The Ringlet select statemachine(Section 7.7.1.6.4; page 186) calls the function Reachable(frame.da,ringlet_id) (Row 24 of state machine , Page :187) to check whether the destination station is reachable on particular ringlet. This function checks the topoEntry[ringlet_id][index].reachable and enqueue the frame if the destination is reachable in that ringlet.

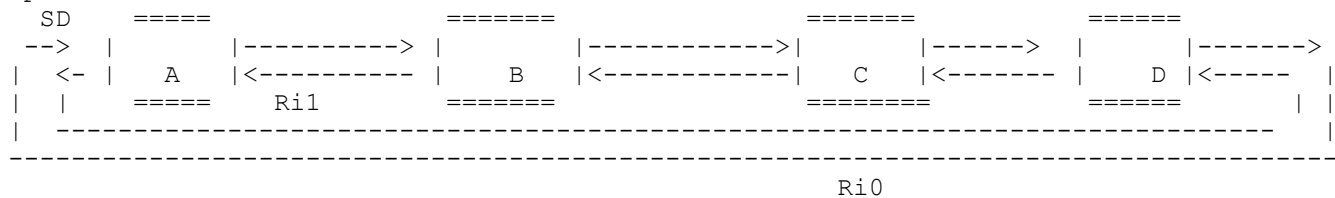
For the failure in the below figure the reachable field of different nodes should be updated as

For Node A
=====
Nodes B, C,D are reachable in ringlet 0 so the entries topoEntry[0][1], topoEntry[0][2], topoEntry[0][3] should have reachable =TRUE and topoEntry[1][1], topoEntry[1][2],topoEntry[1][3], topoEntry[1][4] and topoEntry[0][4] should have reachable = FALSE

For Node B
=====
Nodes C, D are reachable in ringlet 0 and node A in Ringlet 1 .
topoEntry[0][1], topoEntry[1][1] topoEntry[1][2], should have reachable = TRUE and
topoEntry[0][2] , topoEntry[0][3] ,
topoEntry[0][4] , topoEntry[1][3],topoEntry[1][4] have reachable =FALSE.

In the node B will update the topoEntry[ri][hops].reachable when it receive a TP frame from node A on Ringlet1 and node D on Ringlet 0. This is done by ParseTp StateMachine row 27. (Section 11.6.4.4. page 358).

Analysis of TP Frame received on node B
=====
For the TP frame from D received at node B on ringlet 0 ,
Ri =0 , hops = 2 , new.spanEdge [1] = 1 .
This satisfies the condition for row 26 and the topoentries topoEntry[0][2] to
topoEntry[0][MAX_STATIONS] are marked as
reachable =FALSE.
for the TP Frame from A received at node B on ringlet 1 ,
Ri =1 , hops =3, new.spanEdge[0] =1 ,
This satisfies the condition for row 26 and the topoentries topoEntry[1][3] to
topoEntry[1][MAX_STATIONS] are marked as
reachable =FALSE .

So the node B will have entry topoEntry[0][2] are non reachable and topoEntry[1][2] as reachable which could lead to incorrect ringlet selection.

SOLUTION 1
=====
I feel the row 27 & 32 of the state machine should be modified as
topoEntry[Other(ri)][hops].reachable = FALSE .
Maybe the row 28 ,29 and 32 of Protection update state machine need similar
modification.

SOULTION 2
=====
Modify the Reachable(frame.da,ringlet_id) to check for the
topoEntry[Other(ringlet_id)][index].reachable.
